VALUE ENGINEERING REPORT

Florida Department of Transportation

SR 994/SW 200th Street/Quail Roost Drive PD&E Study

Value Engineering Study Report

**VE RECOMMENDATION NO. 1:
 DEVELOP ALTERNATIVE DRAINAGE SOLUTIONS**

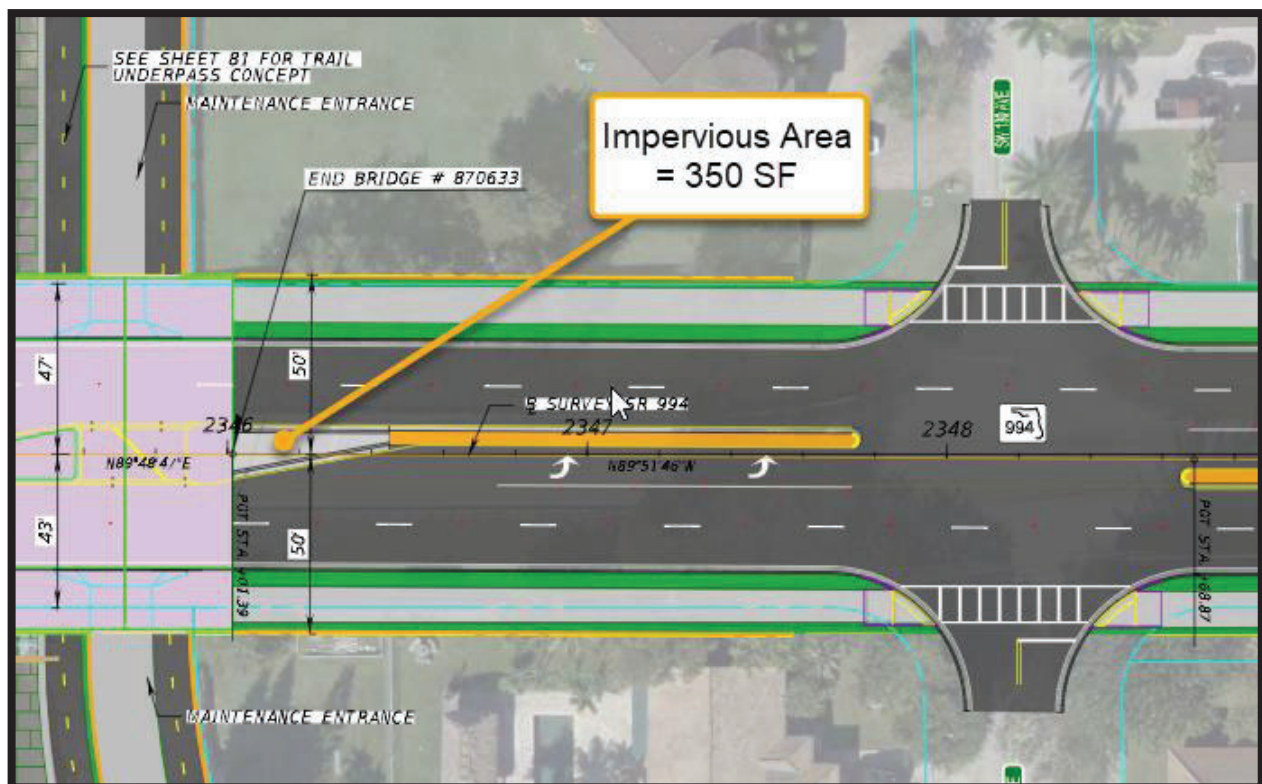
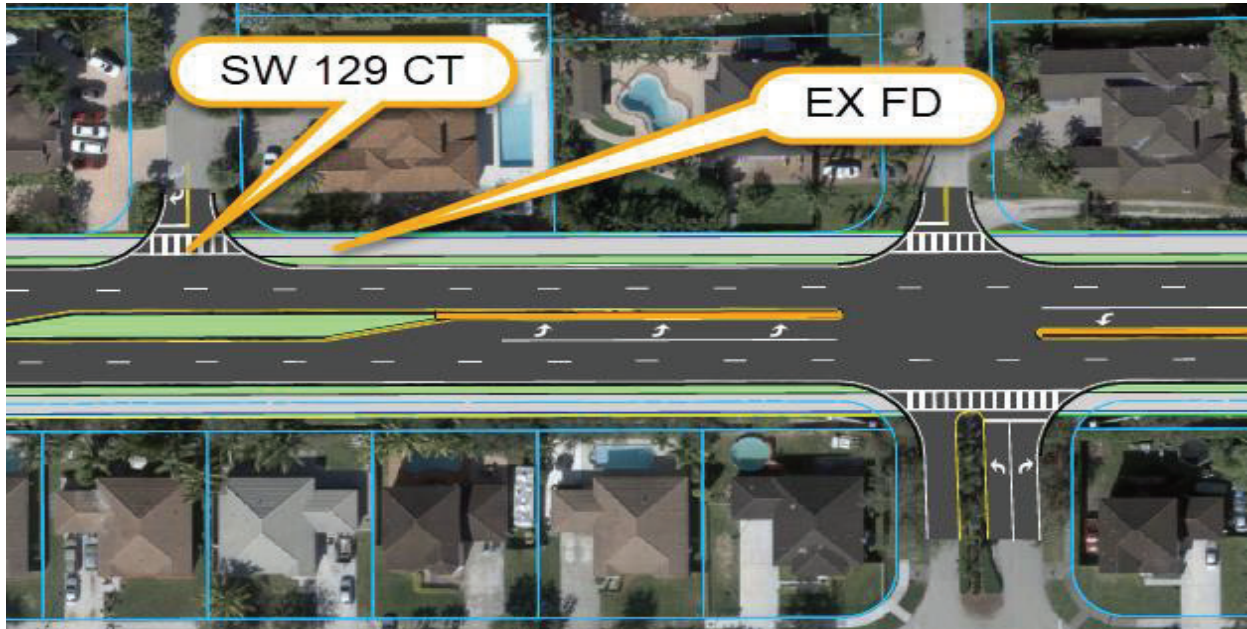
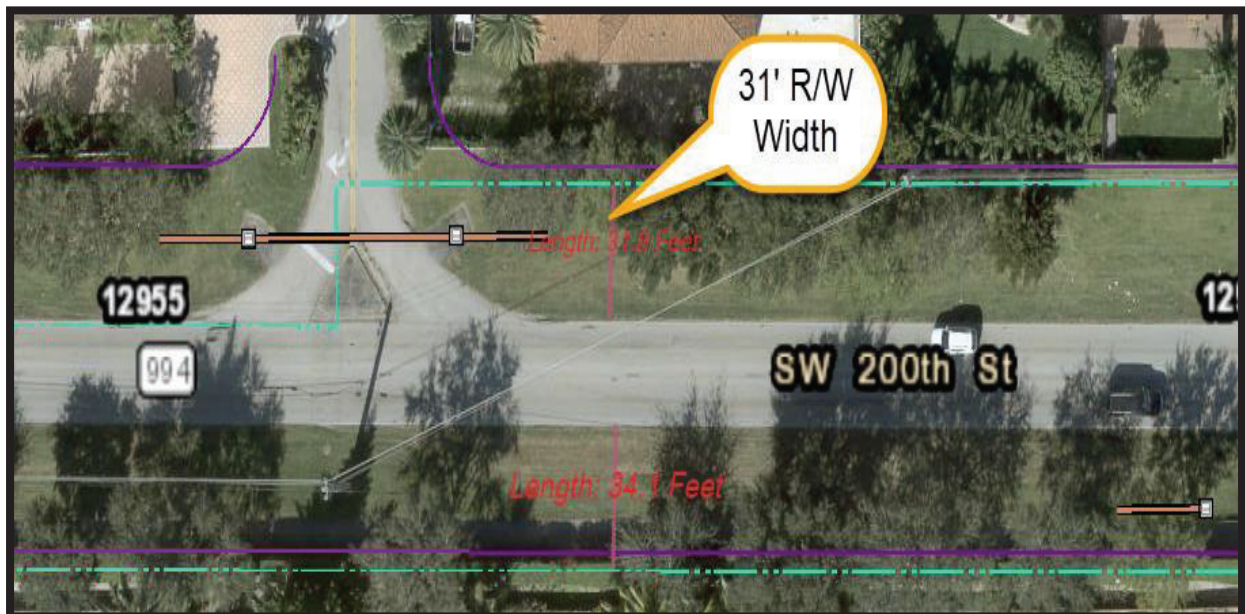
The VE team's recommendation is to explore the usage of swale areas as much as possible to reduce the French drain trunk line system. Additionally, the idea is to remove impervious medians throughout the corridor and replace them with grassy pervious medians. The intent is to stay within the baseline footprint while reducing impervious drainage area.

For example, on the baseline survey of SR 994/Quail Roost at Sta. 2346+00, the baseline concept proposes concrete separator. The VE team calculated the area of the concrete separator at the end of the bridge to be approximately 350 SF. If a grassy median at this area is utilized, the amount of impervious surface will be minimized. See Baseline Figure 1.

At SW127 Ave from STA. 102+00 to STA. 106+00, the baseline concept proposes the construction of a concrete separator (average width of 10-ft and approximate length of 300'). See Baseline Figure 2.

Reduction in impervious area: 10-ft x 300-ft = 3,000 SF approximately

Volume of treatment reduced: 2.5-inch x 3,000 SF/ 12 = 625 cubic feet.

At SW 129th Ct, existing French drains are on the northern side of SR 994/ Quail Roost, see Baseline Figure 3. The available northern right-of-way width from edge of pavement is 31-ft and the other side 34-ft approximately. The proposed baseline concept keeps the existing alignment and widens in both sides, see Baseline Figure 4.

**VE RECOMMENDATION NO. 4:
 USE PREEMPTION TECHNOLOGY**

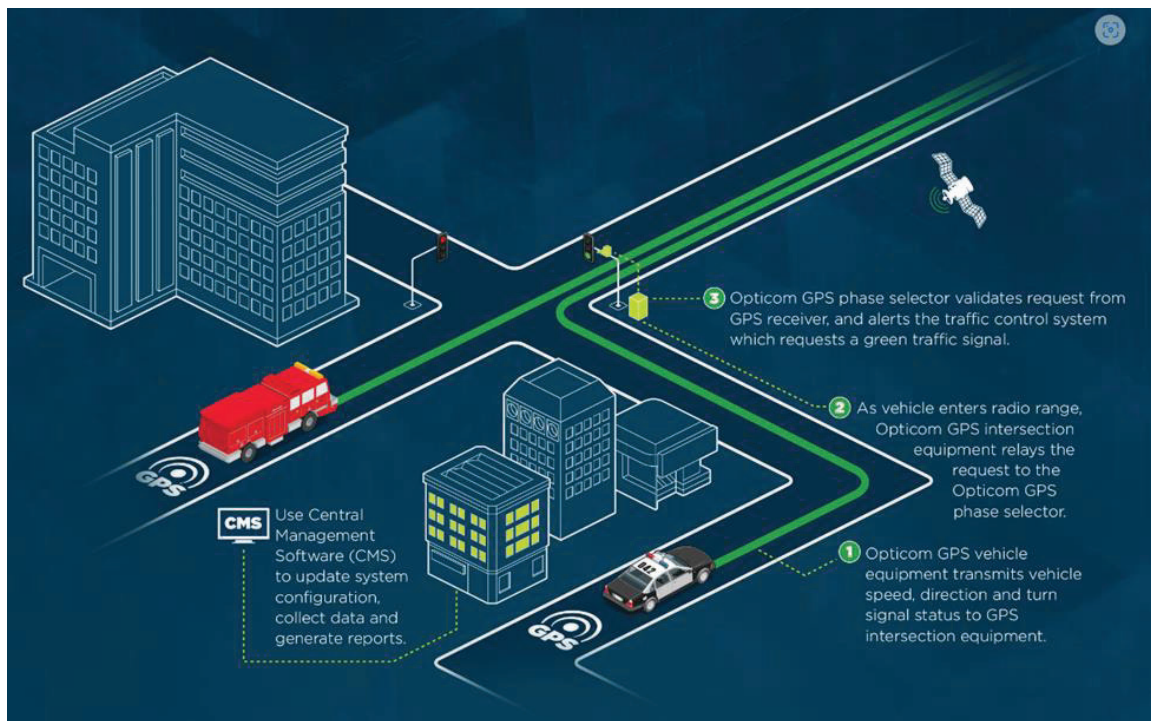
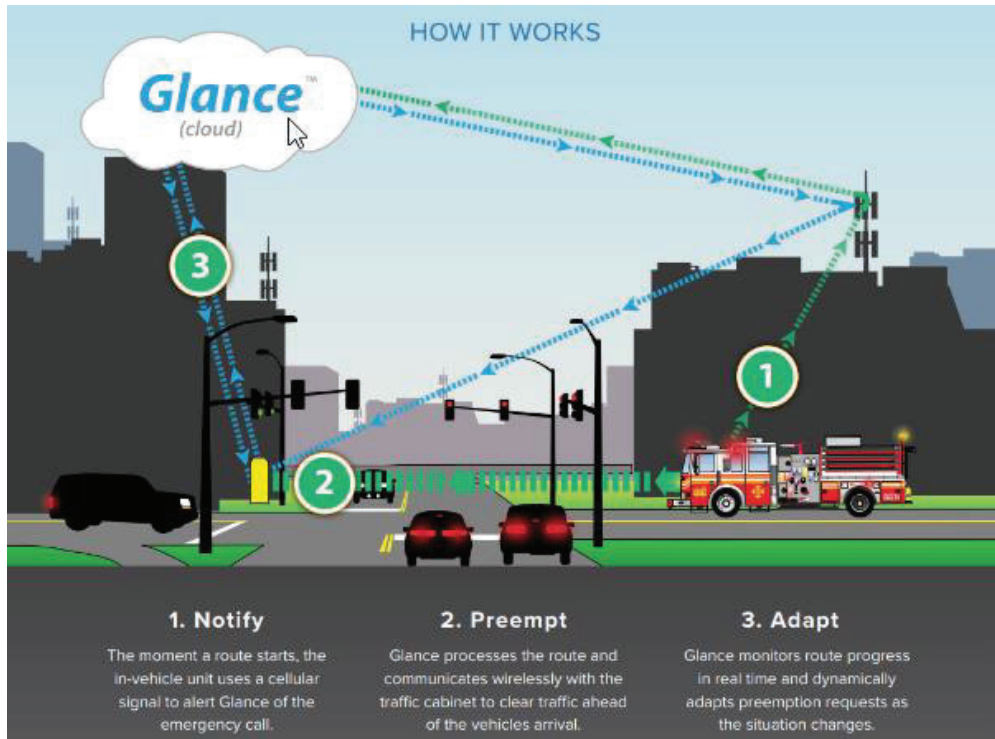
The objective of this recommendation is to improve emergency operations and responses times along the project corridor and improve emergency evacuation. SR994/Quail Roost connects with two highway corridors, SR997/Krome Ave and SR821/Turnpike, designated as emergency evacuation routes that also connects with SR5/US-1 which is a major evacuation for the Florida Keys. The intent is to add new technology along the project corridor to enhance emergency evacuation process and interagency coordination during an emergency event.

Recommendation 2 - Uninterruptible Power Supply (UPS):

This device provides temporary power when commercial AC power is interrupted and prevents failure of normal operations in a signalized intersection. See figure 1

**VE RECOMMENDATION NO. 5:
 MODIFY MEDIAN ACCESS**

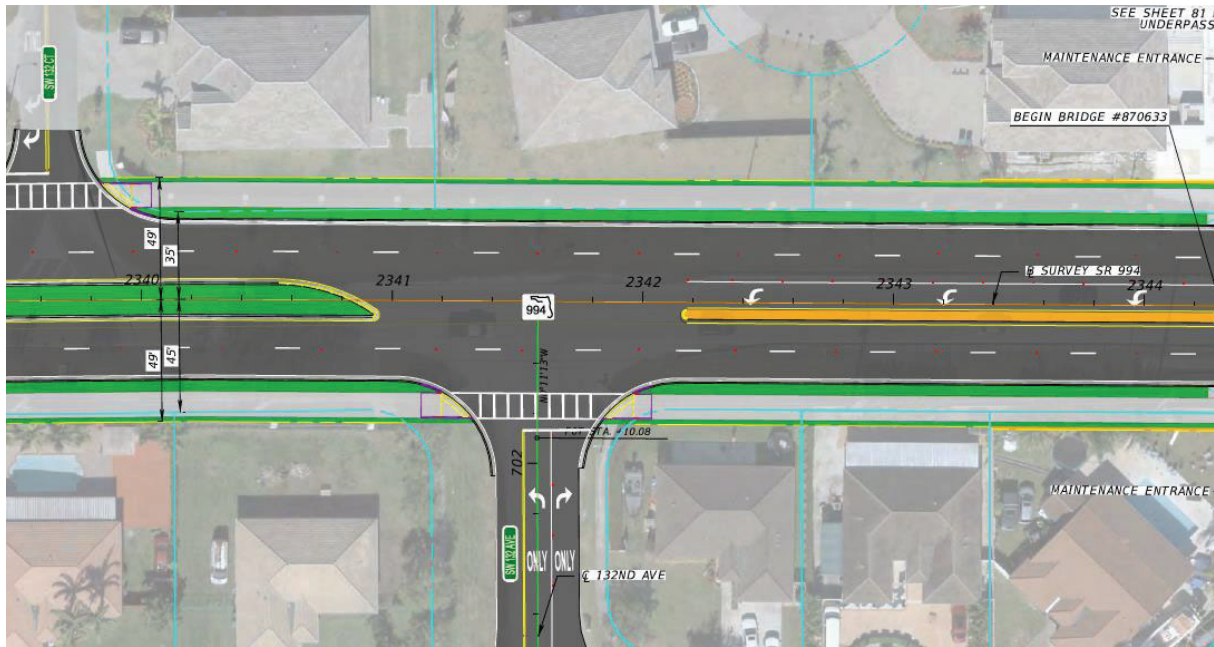
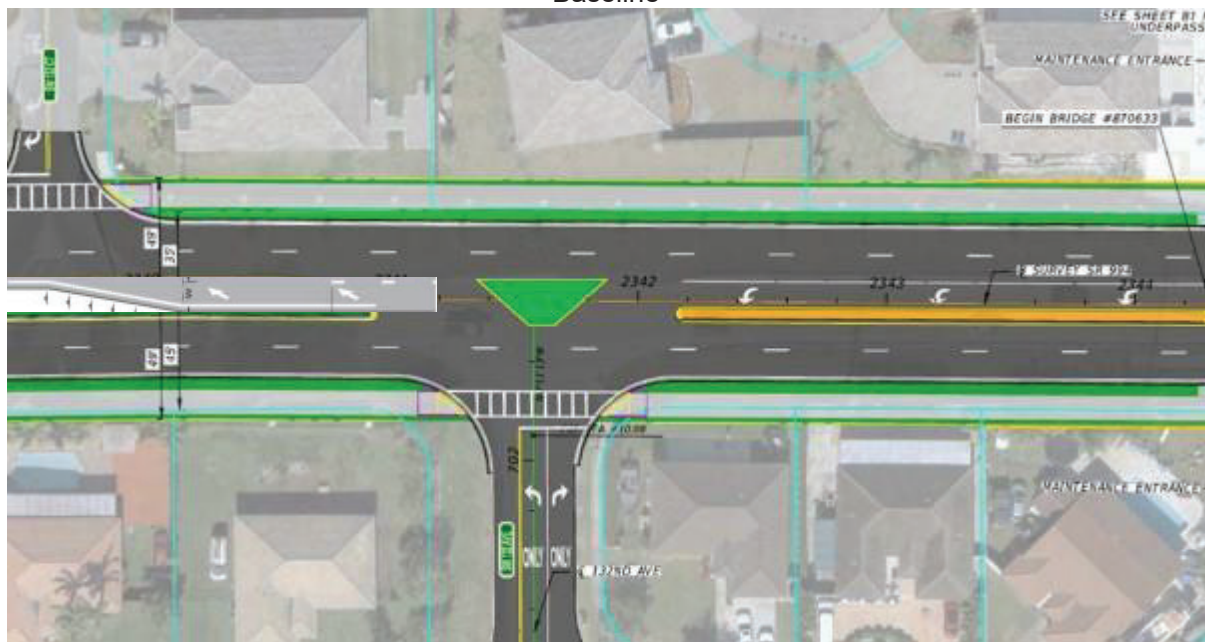
Assumptions/Calculations: For the estimate the VE team considers the construction of concrete directional medians in five (5) intersections, SW 133rd Ct. (WB), SW 130th Ave. (WB), SW 129th Ave. (WB), SW 133rd Ave. (EB), and SW 132nd Ave. (EB).

**VE RECOMMENDATION NO. 6:
 MODIFY SFWMD CANAL ACCESS**

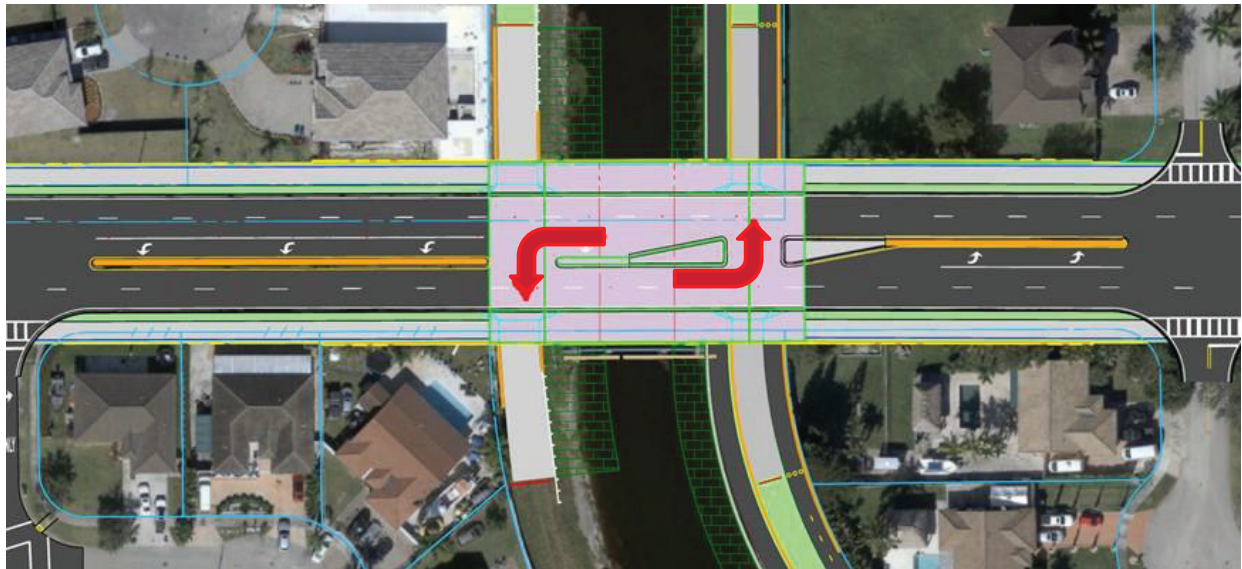
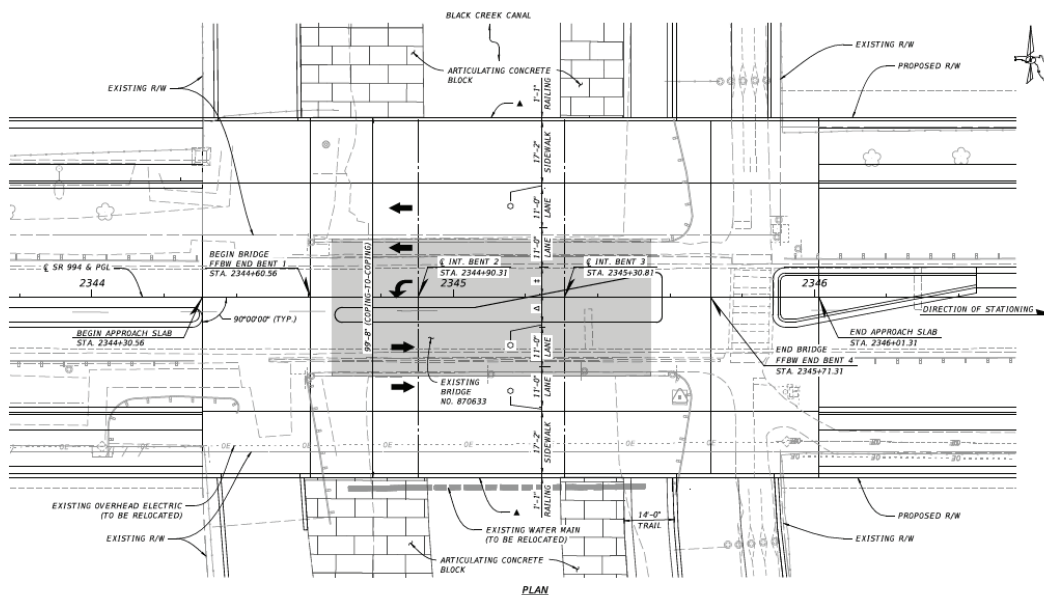
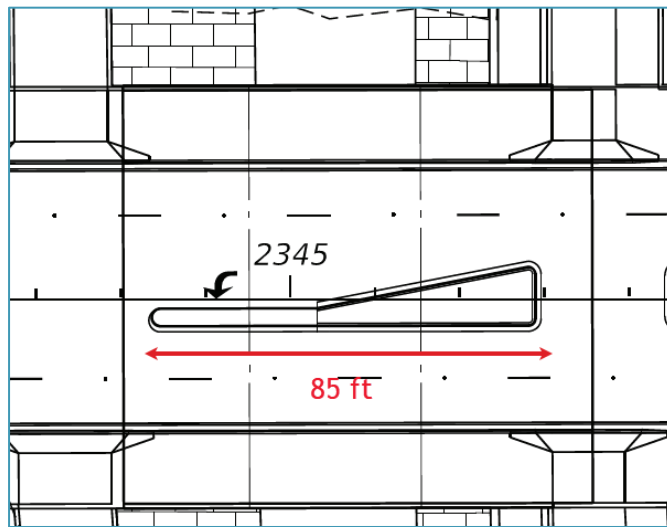
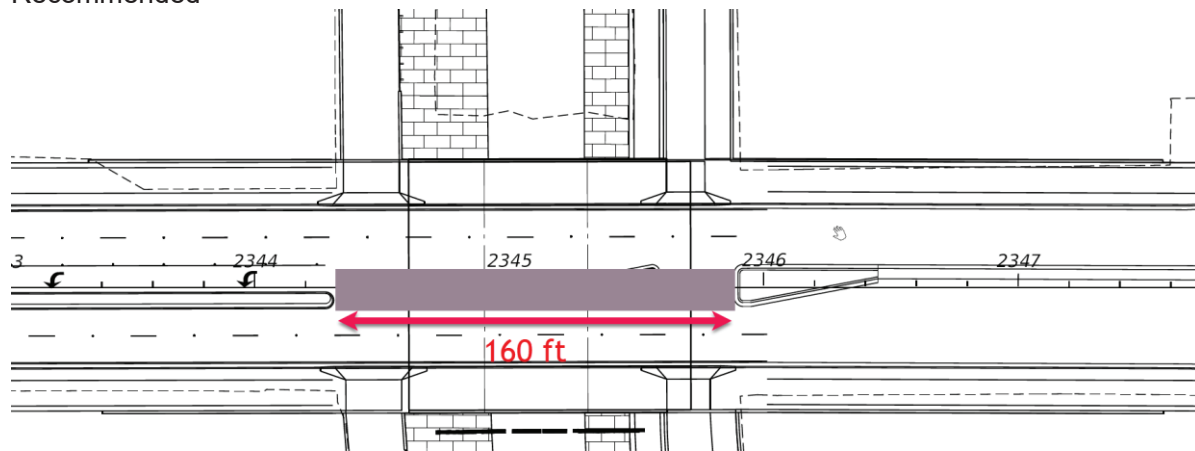
VE RECOMMENDATION NO. 6: MODIFY SFWMD CANAL ACCESS			Idea No. 7		
Baseline Concept					
The base design shows left turn access on the bridge structure crossing Black Creek Canal to provide canal maintenance access to both the north and south sides.					
Recommendation Concept					
The recommended concept is to eliminate the left turn into the North and South side maintenance access South Florida Water Management District (SFWMD) on the structure to reduce conflict.					
Advantages			Disadvantages		
<ul style="list-style-type: none"> • Reduces conflict • Reduces driver confusion • Prevents illegal U-turn 			<ul style="list-style-type: none"> • Reduce access 		
Cost Summary		Construction	Right-of-way	Total	
Baseline Concept					
Recommendation Concept		Negligible		Negligible	
Cost Avoidance/ (Added Value)		Negligible		Negligible	
FHWA Function Benefit					
<i>Safety</i>	<i>Operations</i>	<i>Environment</i>	<i>Construction</i>	<i>Right-of-way</i>

**VE RECOMMENDATION NO. 7:
 REMOVE BUFFER ALONG BRIDGE**

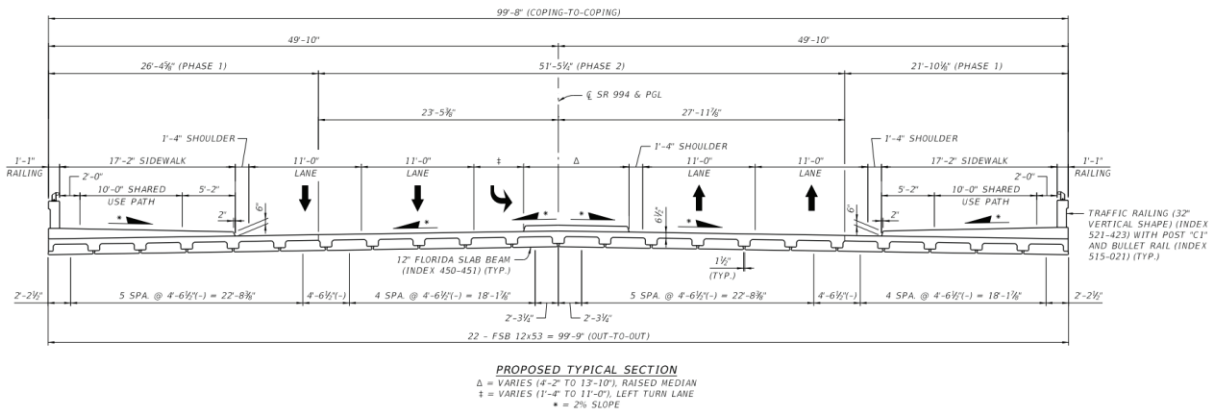
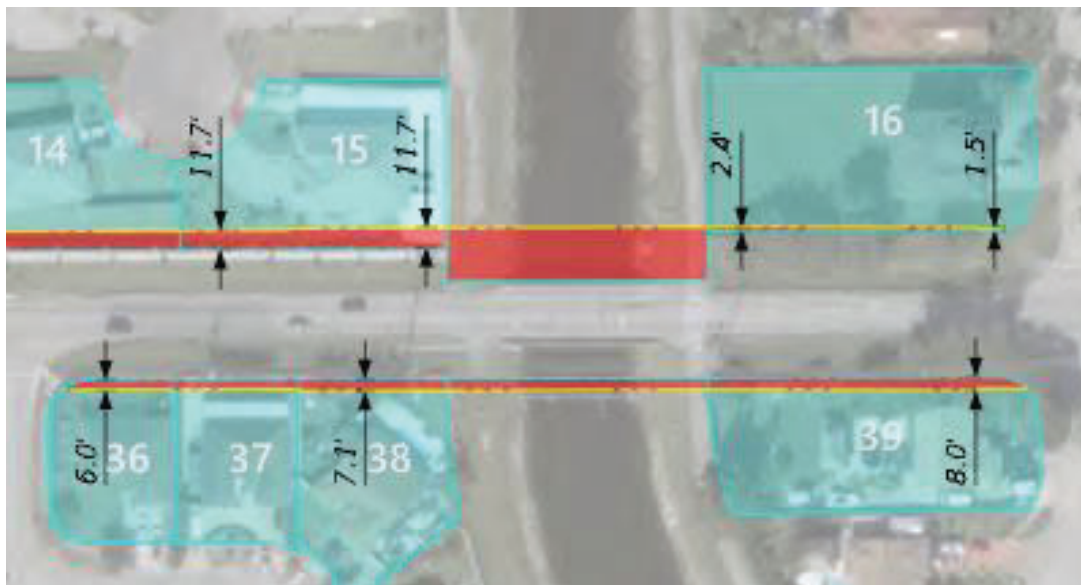
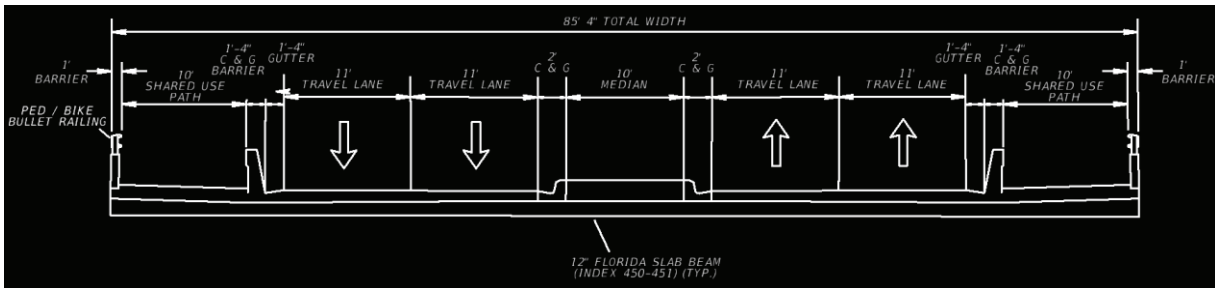
VE RECOMMENDATION NO. 7: REMOVE BUFFER ALONG BRIDGE		Idea No. 9		
Baseline Concept				
The current baseline concept recommends a typical section that is 99'-8" wide and contains a 5'2" buffer between the shared use path and travel lane. The bridge typical section contains a median that varies from 4'2" to 13'10".				
Recommendation Concept				
Remove 5'2" buffer from each side of structure and replace with curb and gutter barriers. Shrink the median as much as needed in order to fit within the ROW.				
Advantages		Disadvantages		
<ul style="list-style-type: none"> • Reduces width of bridge • May reduce construction costs • May reduce ROW need 		<ul style="list-style-type: none"> • Requires design variation • Enables typical section continuity • Reduces distance between pedestrian and vehicles 		
Cost Summary				
	Construction	Right-of-way	Total	
Baseline Concept	\$1,209,247	\$8,438,713	\$9,647,960

This recommendation is to shrink the typical section by installing concrete barriers in the buffer zone to reduce the width of the bridge. The example below shows barrier replacement and a 10-ft median. This design may be modified to accommodate the left turn lane in the median area and provide sufficient shoulder /gutter area as needed. Replacing the 5'2" buffers on each side with a 1'4" barrier.

This recommendation should reduce the bridge typical by 11'6" to 88'2" width. This will reduce the ROW required. An example typical section is shown below but can be modified as needed. This recommendation would reduce or eliminate slivers of ROW and reduce bridge construction cost.
